PCN-20210227 TE0783-02 DDR3, EMMC Change and Product Update

| Company | Trenz Electronic GmbH |
|------------|--|
| PCN Number | PCN-20210227 |
| Title | TE0783-02 DDR3, EMMC Change and Product Update |
| Subject | BOM change |

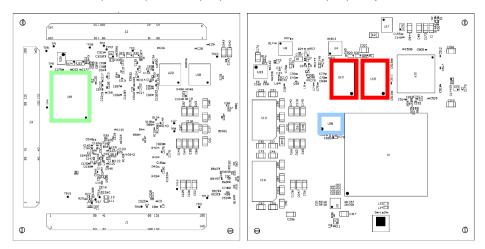
Method of Identification

Locate DDR3 RAM (U10, U19) and Flash (U38) on bottom and eMMC (U28) on top side of PCB:
